STORYTELLER CAFE ADDITION

CIVIL SITE PLAN
STORYTELLER CAFÉ

C1 .pdf V1 - Changemark Notes (5 Notes)

C2.1 .pdf V1 - Changemark Notes (8 Notes)

APPROVED: 3 – 2017 | City of RAMSEY | STANDARD DETAILS: RESET CATCH BASIN CASTING | CITY PLATE No. STO–13

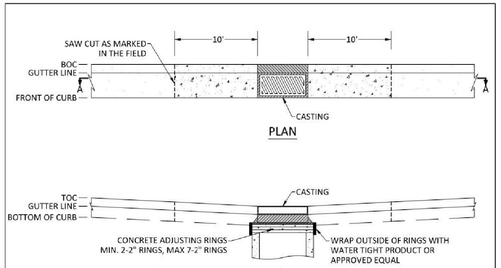
It doesn't appear there are any catch basins that are being reset on this project.

2 RIGHT ELEVATION
SCALE: 1/4" = 1'-0"

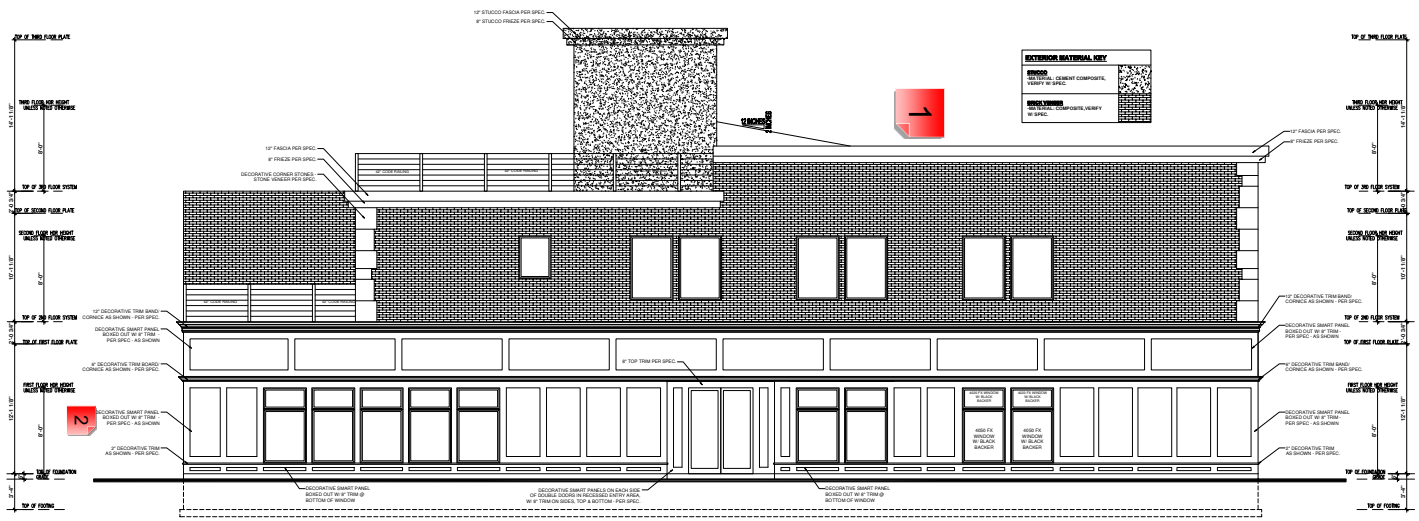
As a restaurant, there will be a lot of RTUs. Please show and screen accordingly.

Please provide additional information on the 'smart panels'. What type of material is it?

Site Plan says to see Architectural drawings for material information on trash enclosure. Please add that to one of the two elevations sheets.

1 REAR ELEVATION
SCALE: 1/4" = 1'-0"

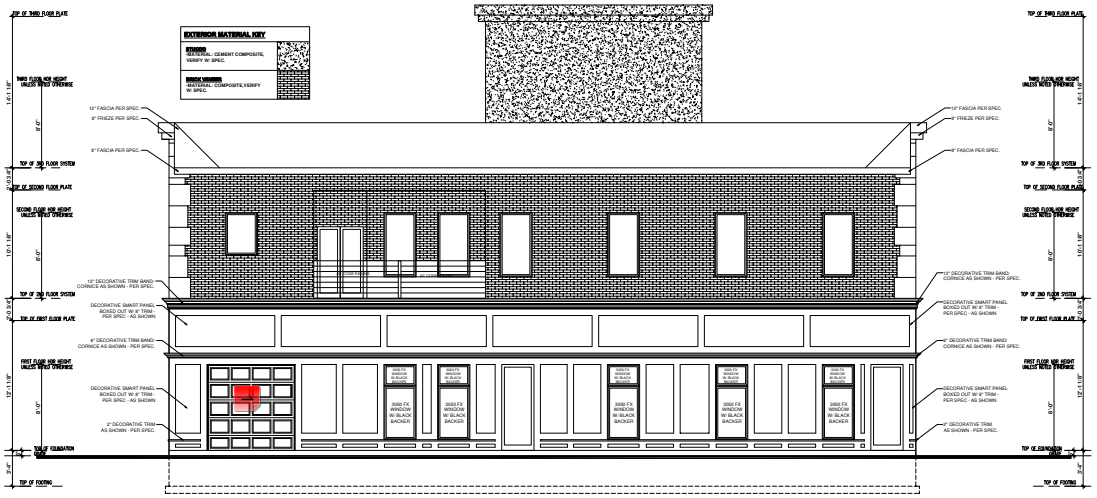
What is this material? Please add label.

1 FIRST FLOOR PLAN
SCALE: 1/4" = 1'-0"

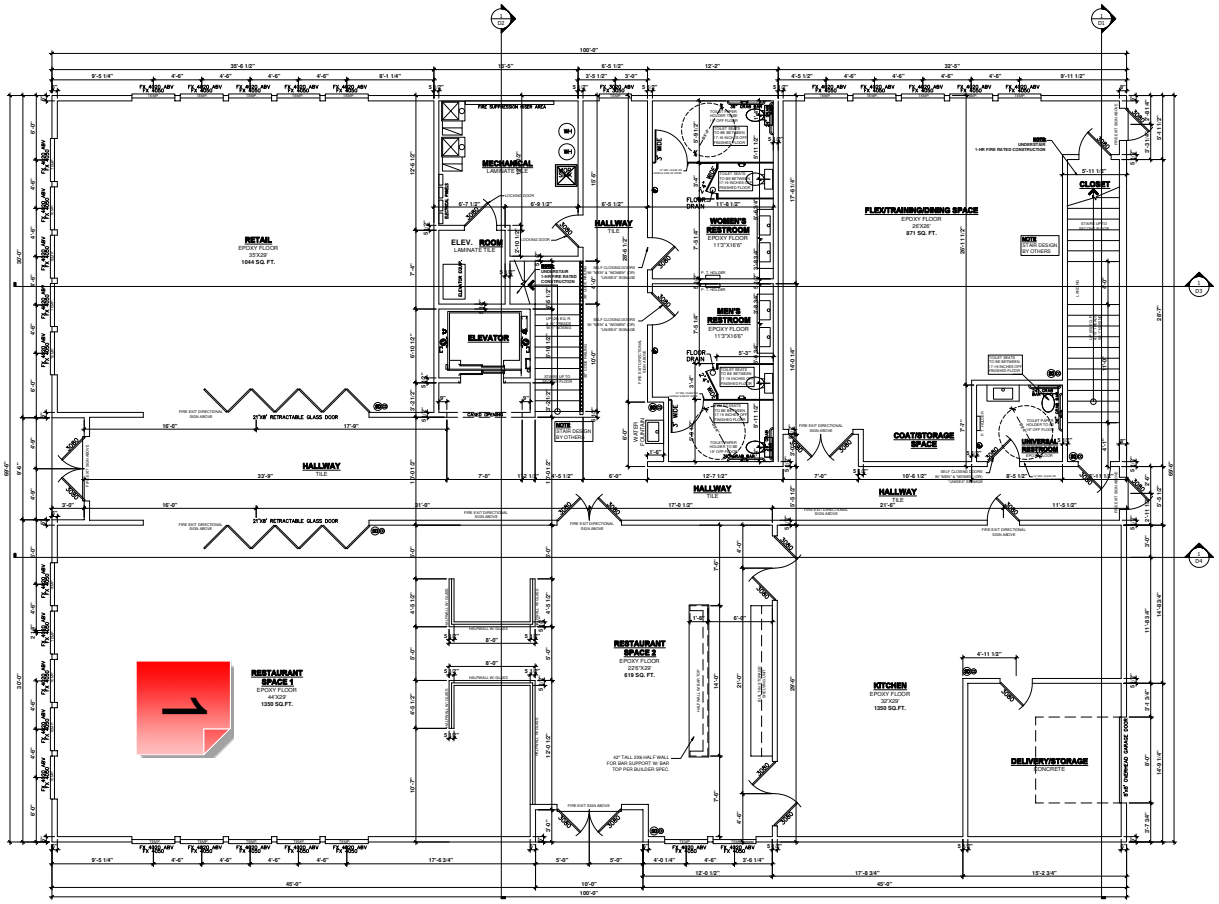
Please provide a count of how many seats will be available in the 2 restaurant spaces. This is needed to verify proposed parking complies with the COR Design Framework (2-4 stalls permitted per 1,000 sq. ft. of retail space; 1 stall permitted per 1-2 seats; 1-2 stalls permitted per residential unit; and 2-3 stalls permitted for every 1,000 sq. ft. of office space).

STORYTELLER CAFE'
RAMSEY, MN
SCALE 1"=8'
DATE 9/14/2023
DRAWING #

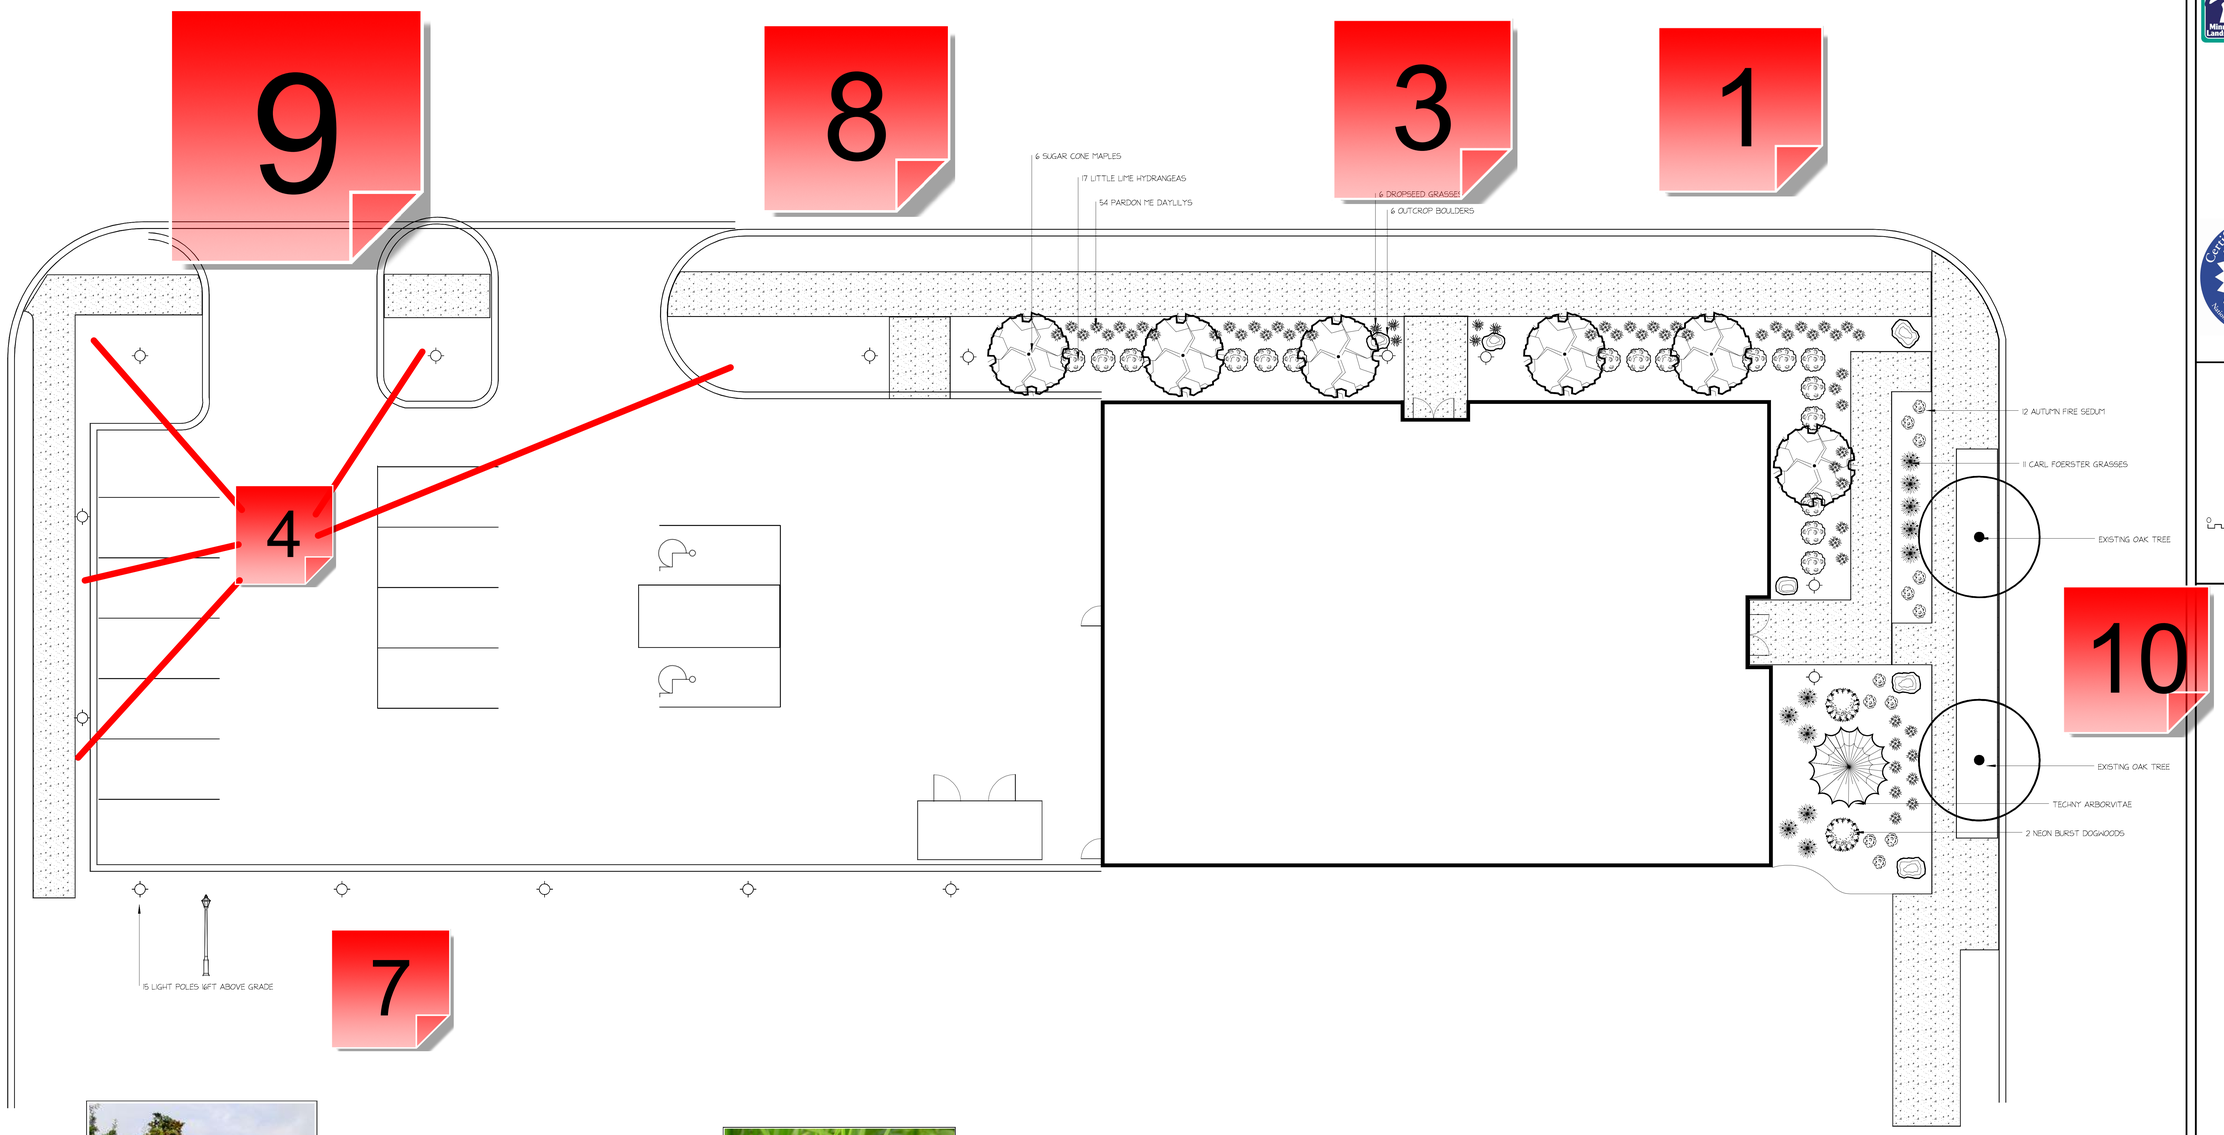
The Landscape Plan layout must be updated to match that of the Site Plan.

Need to provide street trees at a spacing of 30-35 feet on center. Species shall be Accolade Elm to match plantings on west side of Yolite Street. Keep trees out of the vision clearance triangle as defined here:
https://library.municode.com/mn/ramsey/codes/code_of_ordinances?nodeId=PTIICOOR_CH117ZOSU_ARTIIZO_DIV6PEST_SDIINGE_S117-348NEERBULOGREL

Please provide a species pallet or planting schedule that identifies species, quantities, sizes, and root stock.

Please provide a Planting Detail for both trees and shrubs.

Please provide a spec sheet or cut sheet on the proposed lights.

Boulevards along Yolite Street and Veterans Drive shall be finished with sod. Please add label to Landscape Plan.

4 inches of topsoil, with no more than 35% sand content, is required over all disturbed areas nor otherwise finished with impervious surfacing. Add note to Landscape Plan.
